Re: Structural Observation — 106 Micahs Way North, Spring Lake, NC 28390

At your request, on January 6, 2025 we performed a review of the structural plan proposed by *Tar Heel Basement Systems* for the first-floor framing stabilization work at the Spring Lake residence noted above. The structure is a conventionally framed, detached, single family residence with raised first floor framing over a pier/girder foundation system with perimeter masonry foundation walls (see *picture 1*).

Picture 2 – Example of haphazard support

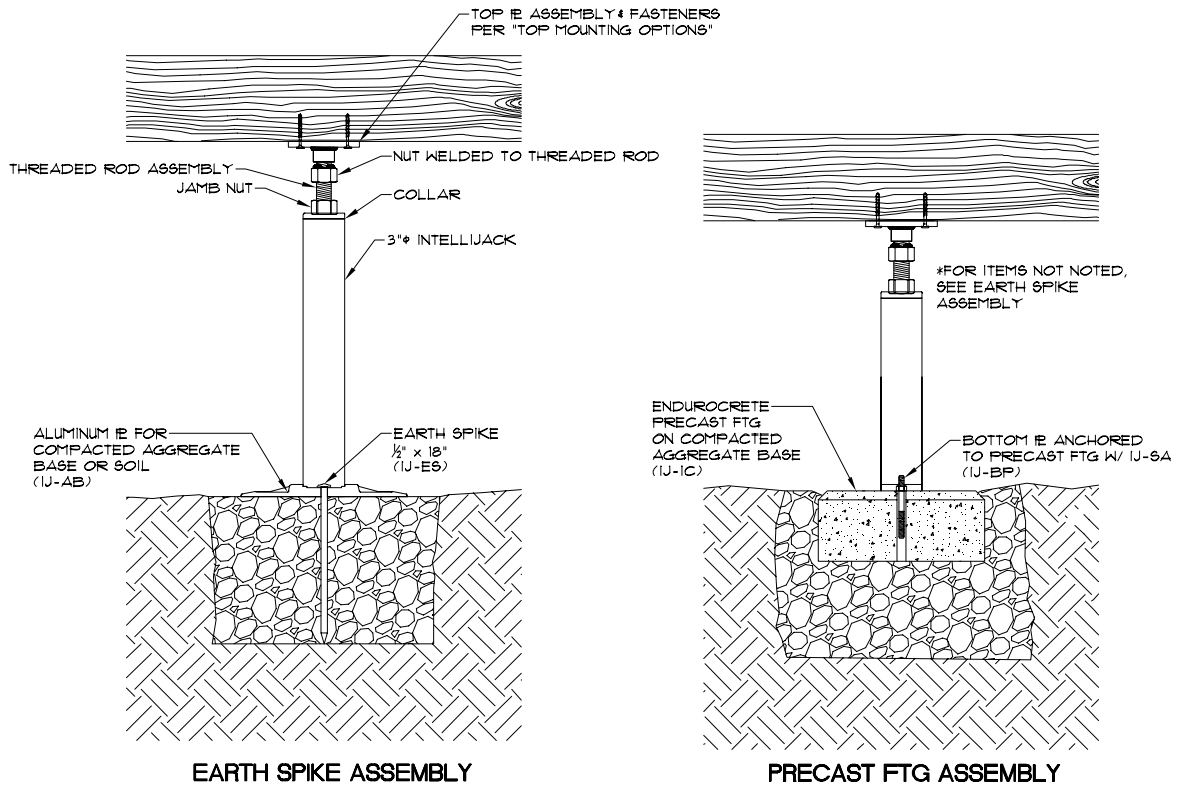
- Between the 2nd and 3rd girder lines from the right, a supplemental dropped girder had been installed. (see *picture 2*).
 - This girder did not appear to be installed to prevent rotation of the girder or appear to have a proper foundation element.

Detail 1 – Intellijack Installation Specifications

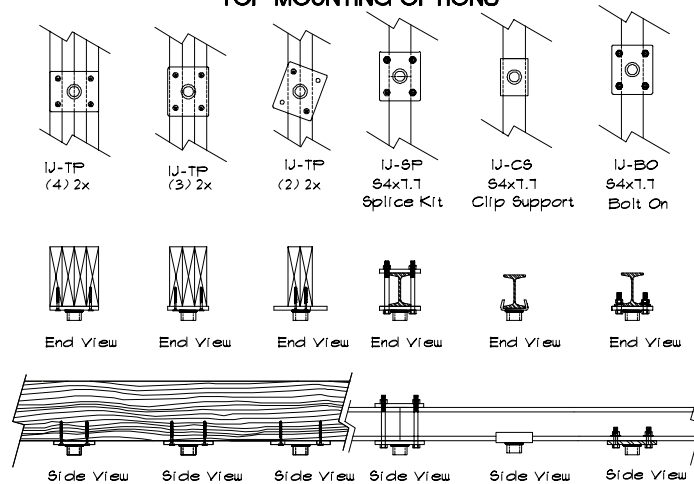
- 1) Reinforce the second girder line from the right foundation wall using an IntelliJack support on a well-compacted 18"x18"x18" gravel footing. Jacks should be located within the middle 1/3 of each girder span and at the approximate locations shown in the attached repair schematic (*see detail 1*).
- 2) Replace the above noted supplemental girder with a new S4x7.7 dropped girder within the middle 1/3 of the joist span. Support the replacement girder using IntelliJack supports on well-compacted 18"x18"x18" gravel footings spaced no more than 6'-6" apart (*see detail 1*).
